SPRINGFIELD PUBLIC SCHOOLS**ADDENDUM NO. 1****Questions, Answers, and Clarifications***Structural Roof and Large-Span Truss Repair Services*

ITB Project No.	25-26/06
OregonBuys Solicitation No.	S-P20019-00016774
Addendum Issue Date	May 27, 2026
Bid Closing	June 2, 2026 2:00 pm, PST
Purpose of Addendum No. 1 This addendum provides consolidated responses to questions received for the current rebid solicitation, confirms selected drawing and specification clarifications, and clarifies the status of Attachment B materials that include historical addendum references from a prior solicitation. This addendum modifies and/or clarifies the solicitation documents only as expressly stated herein. All other terms and conditions remain unchanged. Bidder Acknowledgment Required: Bidders must acknowledge receipt of this Addendum No. 1, including Exhibit A – Revised Specifications, Exhibit B – Prior Solicitation Pre-Bid Walkthrough Sign-In Sheet, all Q&A responses, clarifications, and attachments, by completing the acknowledgment section at the end of this document. Revised Specifications: Revised specification sections are included as Exhibit A to Addendum No. 1 – Revised Specifications and are

Reference Photo 1 - Brattain Campus / Gateways High School: mechanical piping conditions that may interfere with end brackets. Drawings have been revised to allow for fasteners to be moved to avoid the conflict, see revised 1/S8.01.

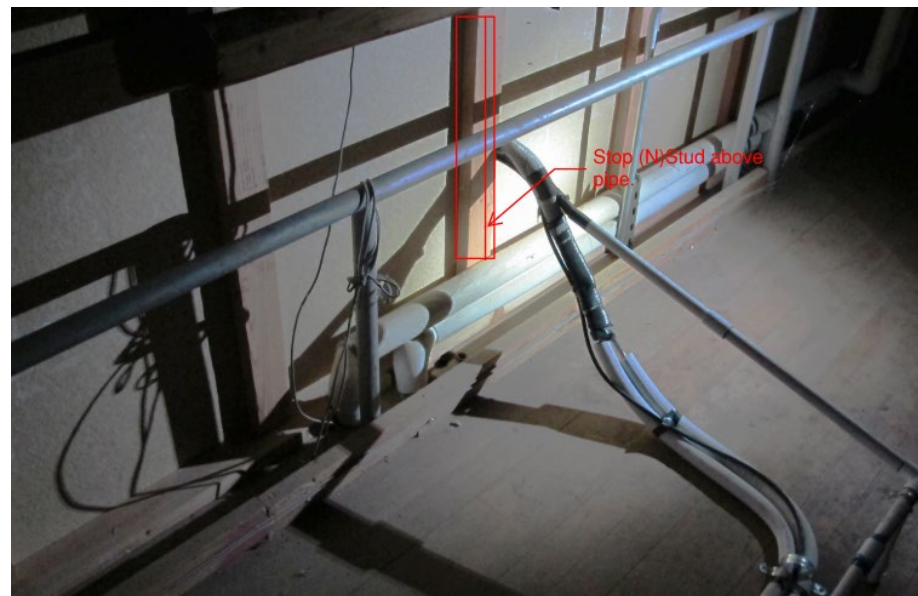
No.	Question / Clarification	Response
G1	Mechanical piping interferes with the end bracket in two locations.	Drawings have been revised to allow fasteners to be moved to avoid the conflict. See revised Detail 1/S8.01 and the reference photo included in Attachment B / this addendum.
G2	Basketball hoop cable hoist conflicts with end anchorage installation.	The basketball hoop cable hoist may be removed and reinstalled as required to allow end anchorage installation. See reference photo included in Attachment B / this addendum.

Reference Photo 2 - Two Rivers-Dos Rios Elementary: Basketball hoop cable hoist can be removed and reinstalled as required to allow for end anchorage installation.

Reference Photo 3 - Two Rivers-Dos Rios Elementary: FRC loft condition showing pipe conflict where added studs may be cut short.
